Department of Planning and Zoning

TO: Development Review Board
FROM: Scott Gustin 
DATE: April 15, 2014
RE: 14-0854CA, 57 Oak Street

Request: Enclose open portions of existing Roosevelt Park storage/pavilion building and install new windows, doors, and lighting.

Roosevelt Park Pavilion Addition
Oak St, Burlington, Vermont 05401

1 NORTH ELEVATION
2.0

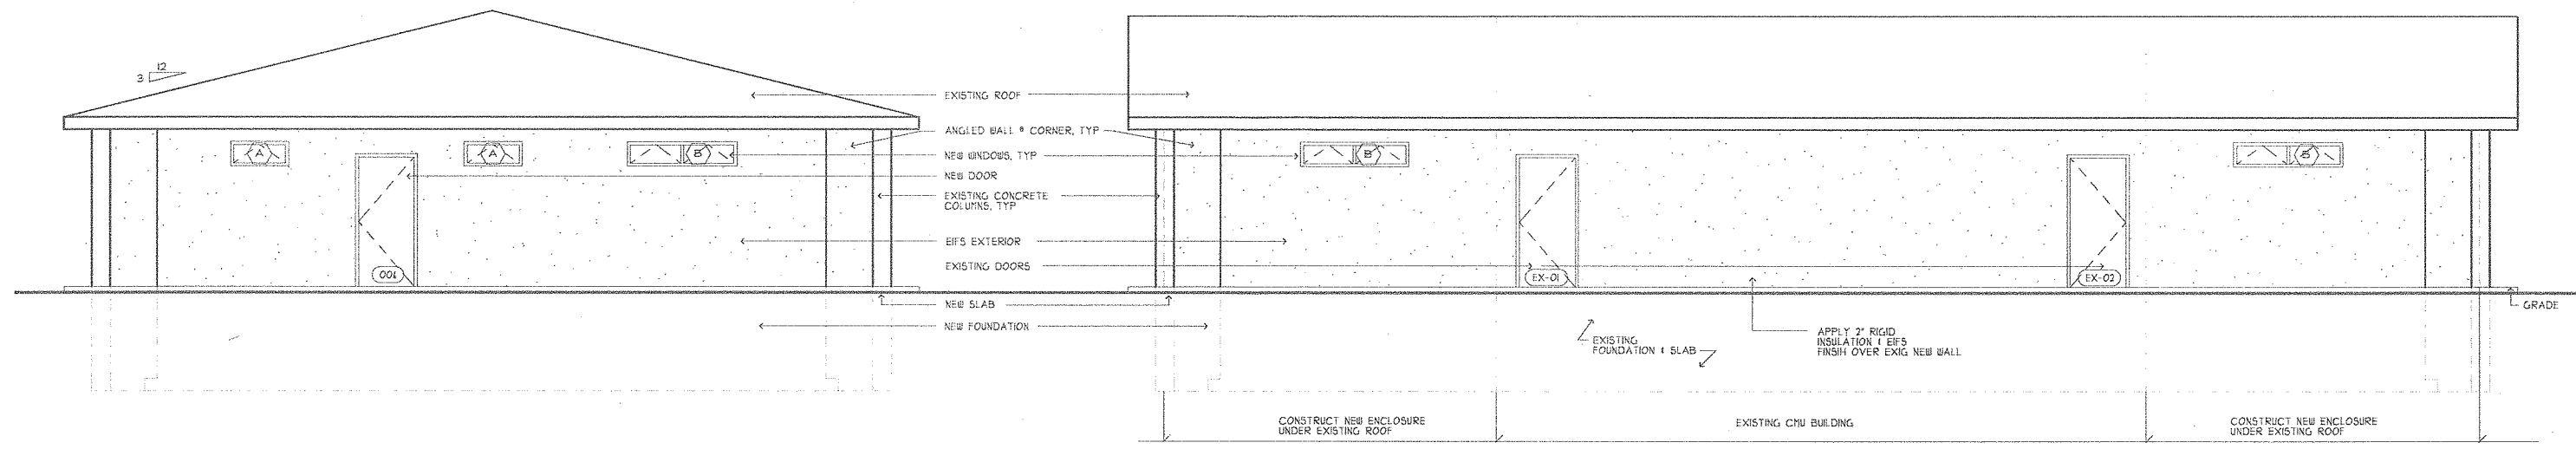
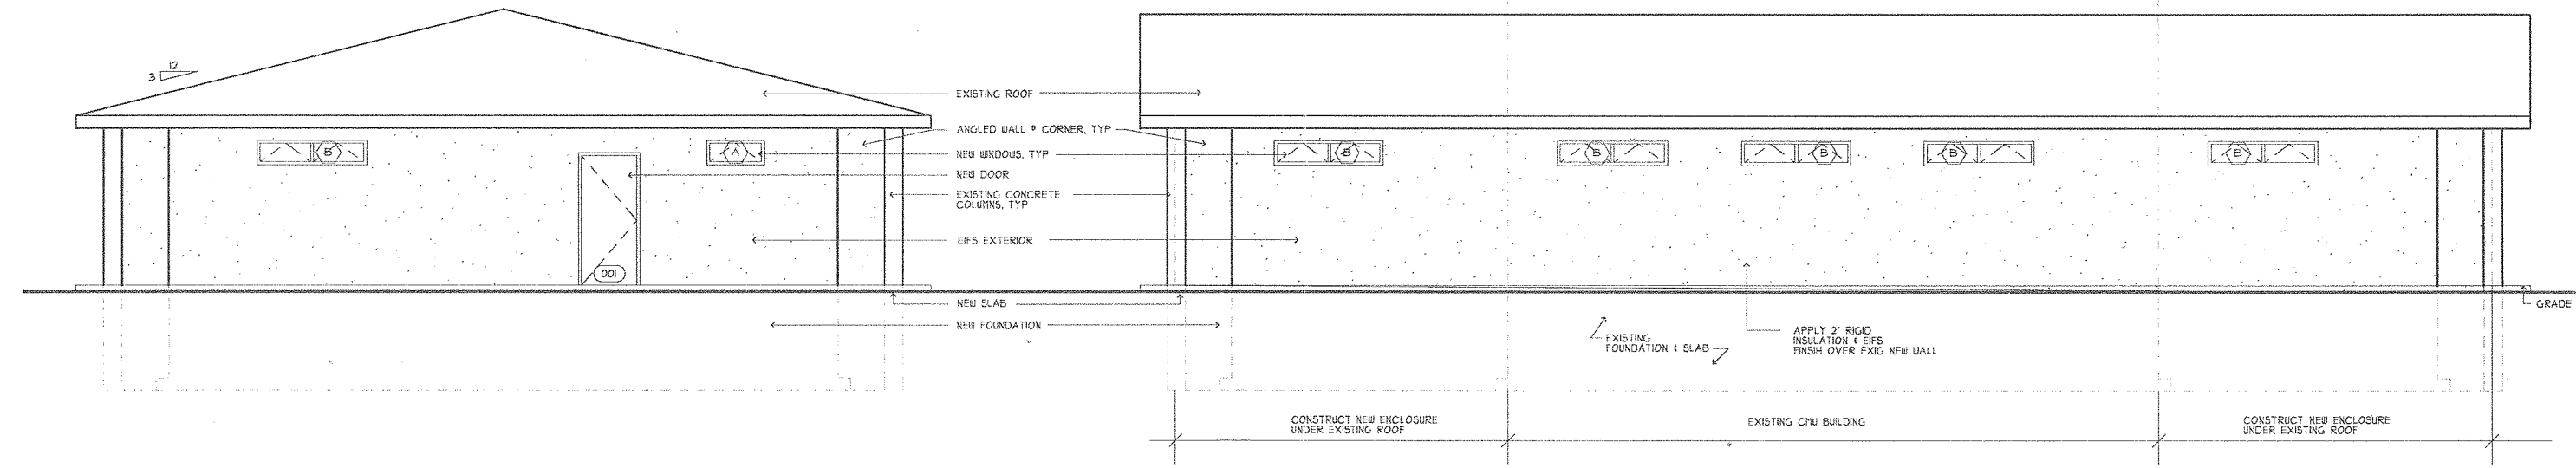
The existing building envelope will essentially remain unchanged. No changes to the roof or foundation are proposed. The north and south open-air pavilion spaces will simply be enclosed. **(Affirmative finding)**

Fenestration is basic and consists of horizontally oriented awning windows that reflect the low-slung horizontal orientation of the building. **(Affirmative finding)**

Roofing will remain unchanged. The new and existing exterior building walls will be finished with EFIS. Clad wooden windows will be installed throughout. While the EFIS is not especially high quality, it is acceptable for this utilitarian parks building. **(Affirmative finding)**

1 FLOOR & LIGHTING PLAN
1.0 3/16"=1'-0"

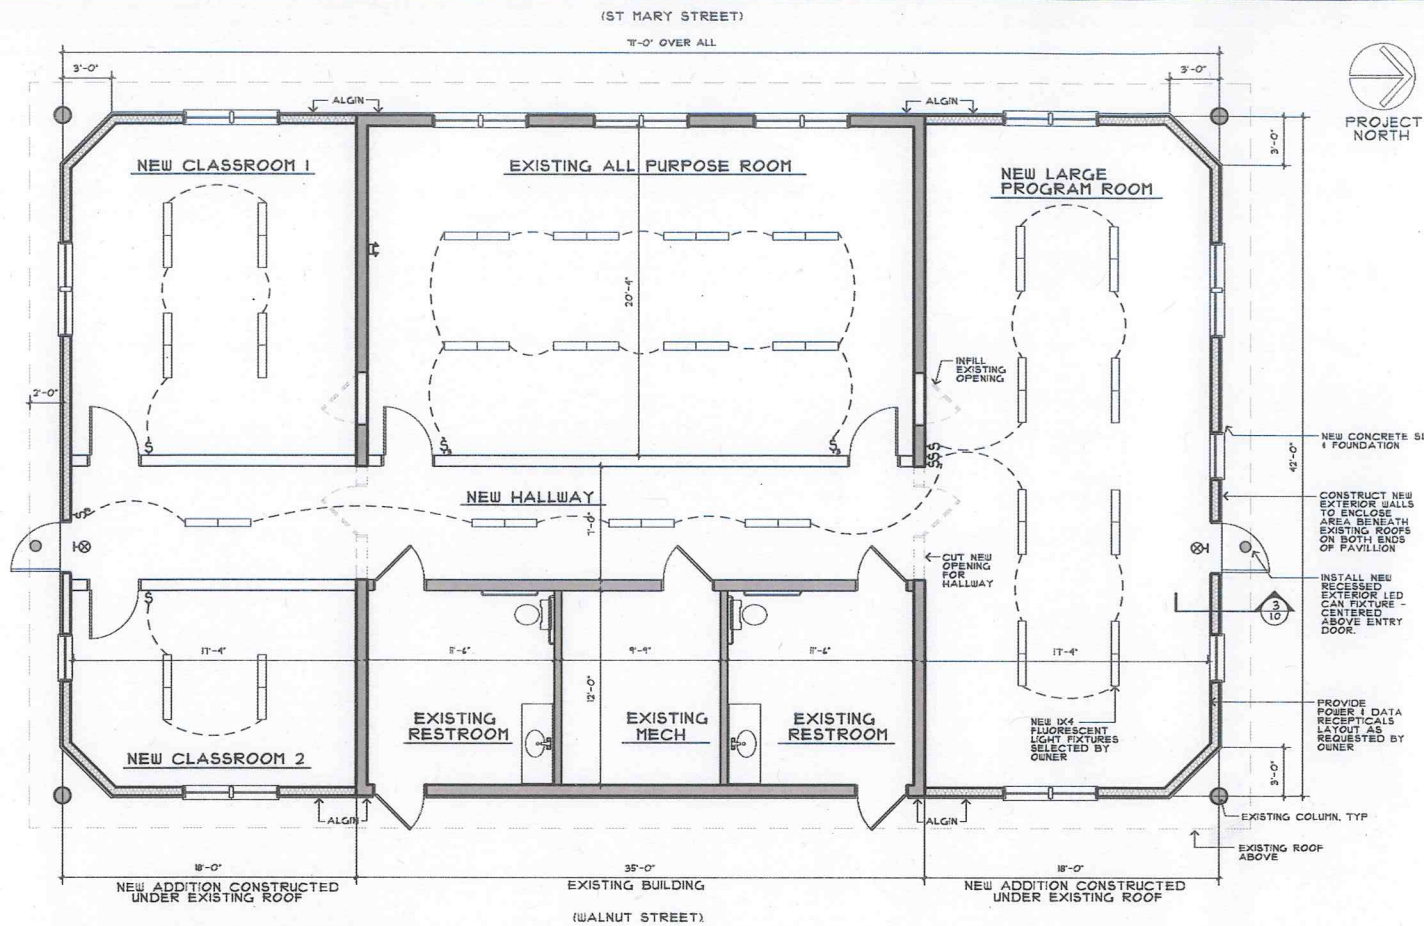
New outdoor lighting is limited to new doorway illumination. The proposed lighting fixtures are to be recessed canister fixtures with LED lamps. No lumen information has been provided and is needed in order to confirm compliance with illumination levels under this criterion. **(Affirmative finding as conditioned)**

1. **Prior to release of the zoning permit**, lumen information for the new exterior lighting fixtures shall be provided, subject to staff review and approval.
2. **At least 7 days prior to issuance of a certificate of occupancy**, impact fees shall be paid to the Department of Planning & Zoning based on the net new building square footage.
3. The Applicant/Property Owner is responsible for obtaining all necessary Zoning Permits and Building Permits through the Department of Public Works as well as other permit(s) as may be required, and shall meet all energy efficiency and ADA handicap accessibility codes as required.
4. Standard permit conditions 1-15.
